Access Compliance Report

Public Rights-of-Way

(Curb Ramps)

Intersection ID: 3137	Main Street: ALAMEDA_LN	Cross Street: STONE_PARK_DR	Location: NE
ADA ID: 6B6E40517752	Ramp Type: PerpDiag	Initial Pass/Fail: Fail	Overall Compliance: No
Severity Score: 8.75			
Codes/Mitigation Info/Possible Solution		Field Measurements/Component Compliance

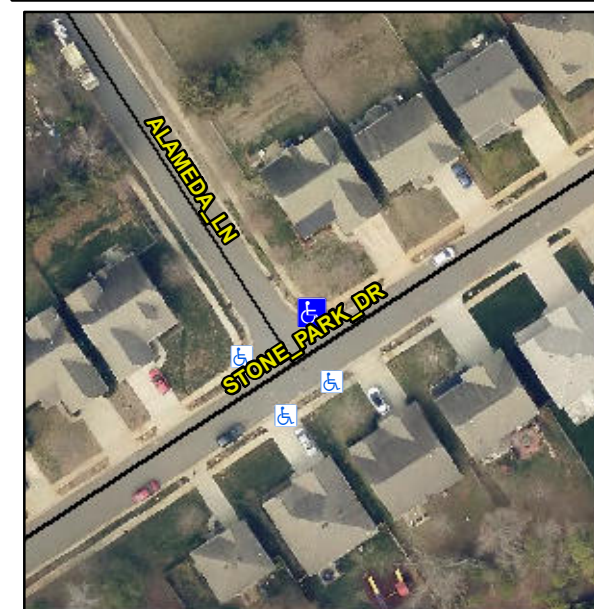
Not Found, R304.5.1

Compliance	Description	Data	Compliance	Description	Data
N/A	Ramp Length (in)	50.0	Yes	Ramp Slope (%)	8.0
No	Ramp Width (in)	37.0	Yes	Ramp XSlope (%)	0.2
N/A	Flare Type LT	N/A	N/A	Flare Type RT	N/A
N/A	Flare Slope LT (%)	N/A	N/A	Flare Slope RT (%)	N/A
N/A	Flare Traversable LT?	N/A	N/A	Flare Traversable RT?	N/A
N/A	Landing Length (in)	N/A	N/A	DWS Provided?	N/A
N/A	Landing Width (in)	N/A	N/A	DWS Contrast?	N/A
N/A	Landing Slope (%)	N/A	N/A	DWS Length (in)	N/A
N/A	Landing X Slope (%)	N/A	N/A	DWS Full Width?	N/A
N/A	Landing Curb? (Y/N)	N/A	N/A	DWS Offset (in)	N/A
N/A	Shared Landing?	N/A			
N/A	Gutter Ponding?	N/A	N/A	Gutter Slope (%)	N/A
N/A	Gutter Lip Ht (in)	N/A	N/A	Gutter X Slope (%)	N/A
N/A	Painted X Walk1?	No	N/A	Painted X Walk2?	No
	X Walk 1 Direction	To W		X Walk 2 Direction	To S
N/A	X Walk 1 Width (in)	N/A	N/A	X Walk 2 Width (in)	N/A
	X Walk 1 Slope (%)	1.0		X Walk 2 Slope (%)	0.4
	X Walk 1 X Slope (%)	0.3		X Walk 2 X Slope (%)	0.8

Remove & Replace Curb Ramp With Two New Directional Ramps or Equivalent.
